CITY OF KEY WEST

ADDENDUM NO. 3 CAROLINE STREET IMPROVEMENTS / ITB 15-007

CAROLINE STREET PARKING LOT	
900 BLOCK OF CAROLINE STREET	
KEY WEST, FL 33040	
SITE PLAN

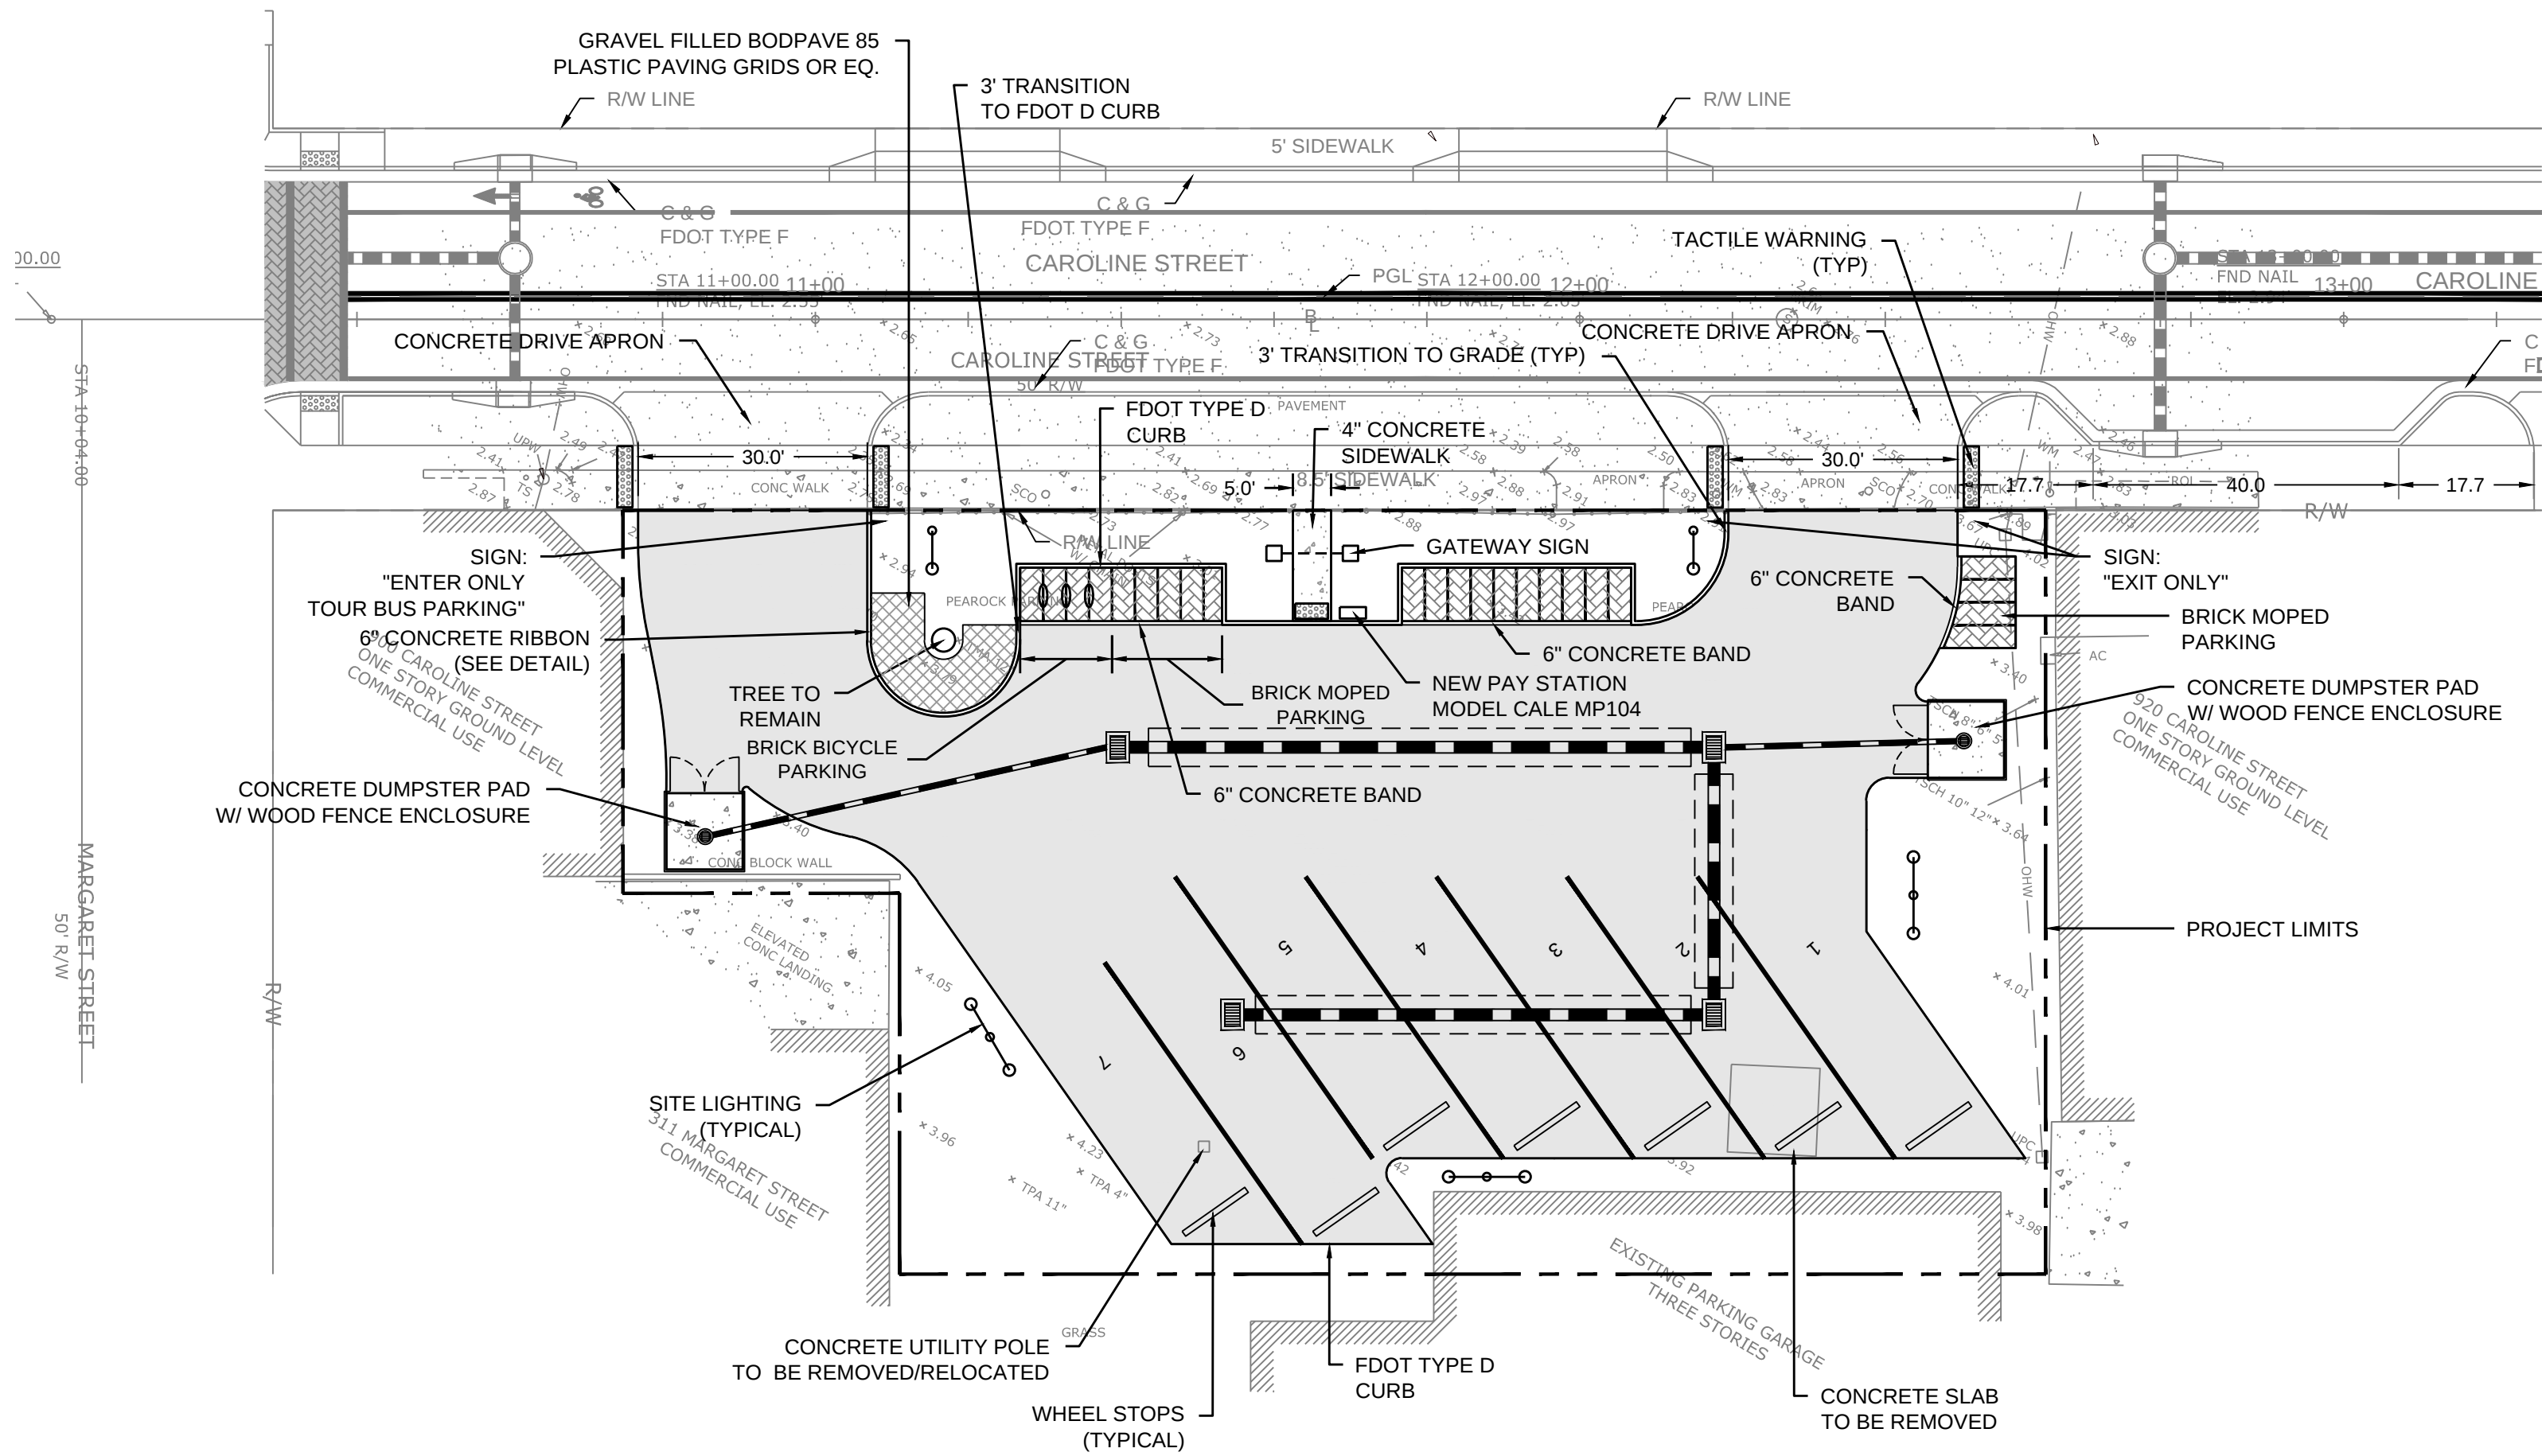
<u>Sheet(s)</u>	<u>Description</u>
C-1, C-2 and C-3	Drawings for Parking Lot addition at 900 block of Caroline Street referenced in ADD ALTERNATE - Caroline Street Parking Lot, page 00 41 13-5 of the Bid Documents.
